SSD 16_7894: CHAU CHAK WING MUSEUM UNIVERSITY OF SYDNEY, CAMPERDOWN CAMPUS

UNIVERSITY OF SYDNEY RESPONSE TO SUBMISSIONS – SUPPLEMENTARY INFORMATION

22 JANUARY 2018

JPW DA- L-0500 Rev 1

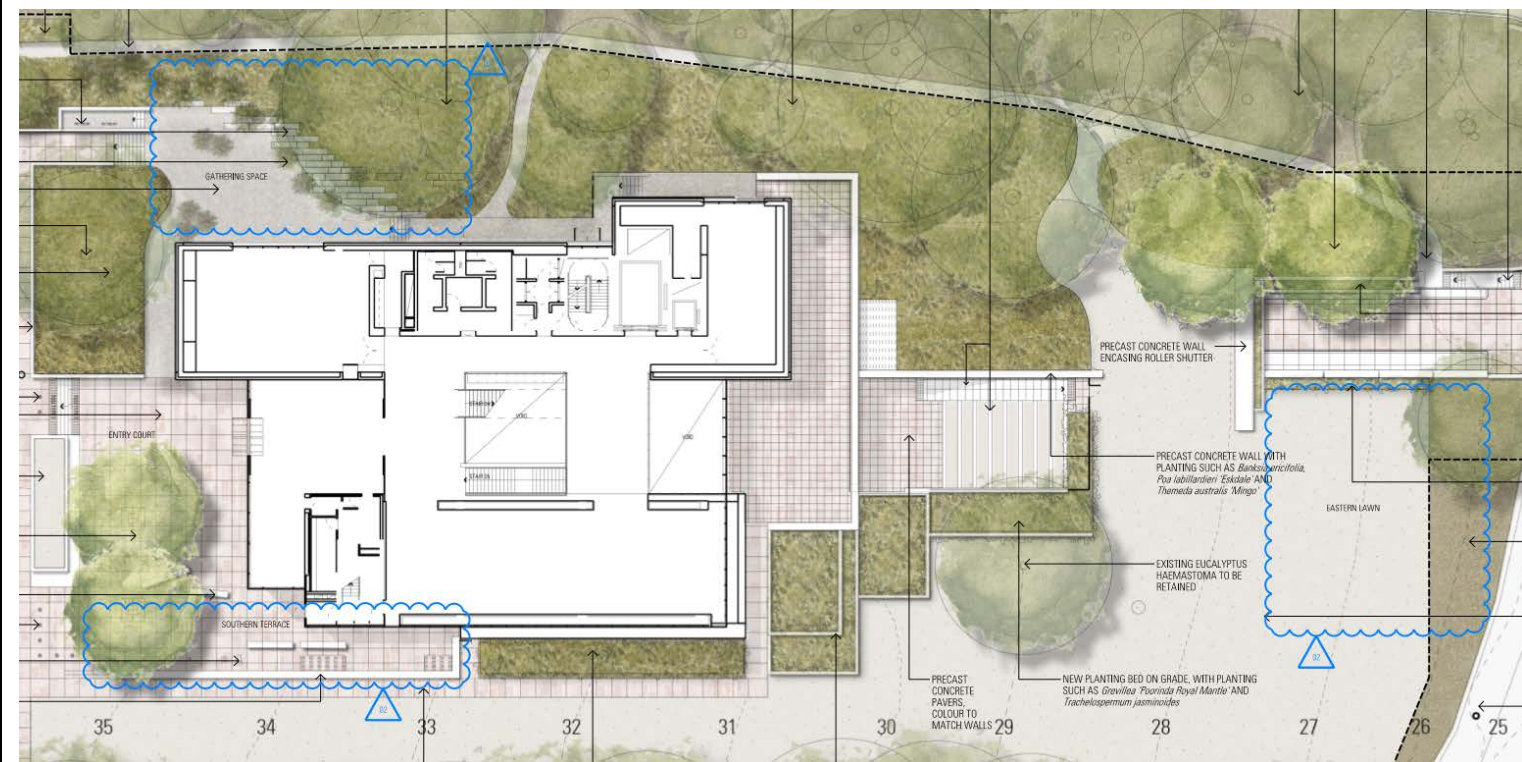
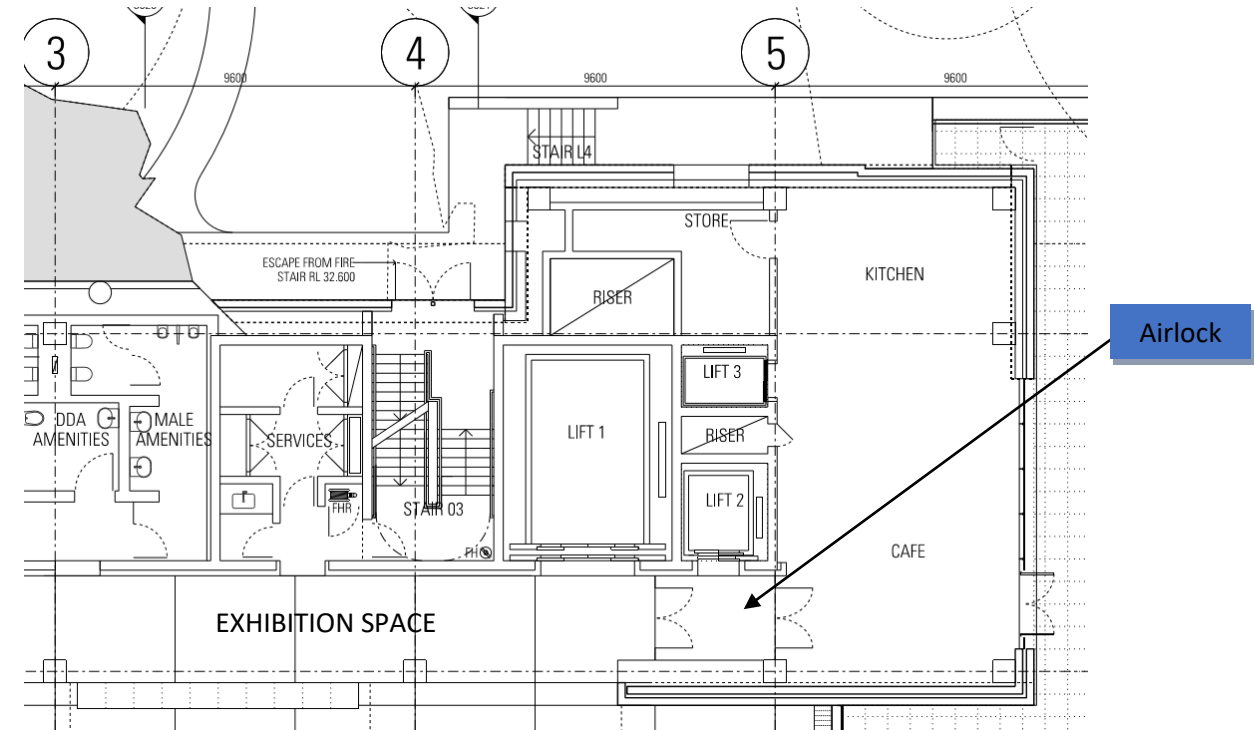
SSD 16_7894 – CHAU CHAK WING MUSEUM	
OGA KEY ISSUE	UNIVERSITY PROJECT RESPONSE
<p>1. No changes have been made to the southern interface of the building, therefore it cannot be said that the applicant has considered or improved the public domain as recommended. It may be that small terraces, landscaping or outdoor 'rooms' that do not have physical connections into the building can be provided, which utilise the southern elevation as one 'wall' to those spaces and which would provide some interest to pedestrians walking from the gates to the University Lawn</p>	<p>USyd: The University has considered the additional comments provided by the GA office (received by the University on 17 Jan 2018), and provides our response to the issues addressed below. Furthermore, the University's architect JPW is also contacting the GA office to provide further clarity and answers to any questions in this matter.</p> <p>The University disagrees with this position and draws the DPE and GA attention to the revised plan JPW-DA-L0500 revision 2 (Appendix A). The Public Domain landscape area, juxtaposed to the southern Museum building façade, has been expanded to incorporate a variety of hard and soft landscape terraces at various levels. This expansion forms part of the proposal's expansion of the principal Museum entrance forecourt, provision of a gathering space to the north-west of the entrance forecourt, provision of informal outdoor education areas, and provision of the physical secondary pedestrian connection running alongside University Avenue towards the University Place lawns further west. See the public domain comparisons on page 4 showing the changes since the last submission. These elements all contribute to the variety, visual interest and activation of the public domain fronting the Museum's southern elevation.</p> <p>DPE is reminded that no physical penetrations are intended through the southern Museum façade due to the careful climate control requirements of the Museum displays within the building (including artefact vulnerability to light) as well as security reasons in protecting valuable artefacts contained within the building. Carefully positioned slot windows do however offer the passer-by a glimpse of the Museum collections within, and provide a degree of activation.</p> <p>Finally, DPE is reminded that the expansion of the southern pedestrian link and landscaping is confined in width due to the University's intention to protect the tree roots of the High Significance heritage trees (as identified by the University's Grounds Conservation Management Plan) lining the University Avenue approach, and the desire of both the University and the Heritage Council to preserve the lawn curtilage and view axis up to the Quadrangle Building.</p>

OGA KEY ISSUE	UNIVERSITY PROJECT RESPONSE
<p>2. The summary states that an additional 'gathering space' has been provided to the northwest, however, developed drawings to demonstrate this have not been provided.</p>	<p>USyd: The University highlights the revised Ground Plan L-0500 version 2 which was submitted with our Response to Submissions document. The Plan (refer to page 4) highlights the new 'Gathering Space' at the northwest campus domain outside the building and the comparison with the original SSD Plan Revision 1 illustrates the extent of the new area. This space is designed and located specifically adjoining the intersection of the University lawn and Museum entrance in consideration of the University's <i>Wingara Mura-Bunga Barrabugu Strategy</i> and will provide an area for ceremonial activities and informal gatherings. The new gathering space is approximately 100m2.</p>
<p>3. The intent to provide open public space associated with the entry to the west and the northern façade and landscape is supported.</p>	<p>USyd: Noted</p>
